Modifications REQUIRED to Plus 3 board
Disconnect pins 3 and 13 of IC9 from board.
Connect pins 3 and 13 of IC9 to ground

TITLE: plus3_ramrom

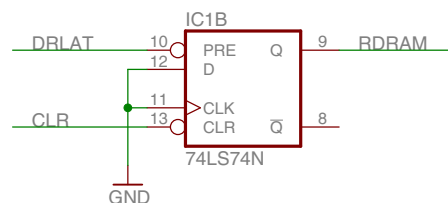
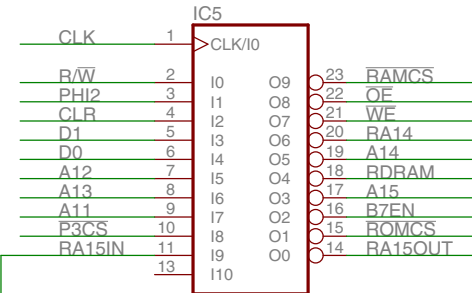
Note if using 128K, 256K or 512K FLASH/EPROM, then Code must be in the *TOP* 64K of the ROM

If using 32K or 64K ROM then plug into bottom 28 pins
Leave pins 1,2,31,32 unconnected

CLK to IC10 pin 6 PHI2 to IC10 pin 5
DRLAT to IC10 pin 8
R/W to IC8 pin 9
CLR to IC12 pin 1 or IC15 pin 1 (RESET)
A14 to IC7 pin 5 A15 to IC7 pin 4

JP1: For 27256, 2-4, for 27512, 4-6
JP2 1-3 for bank 7 RAM, 3-5 for bank 7 ROM
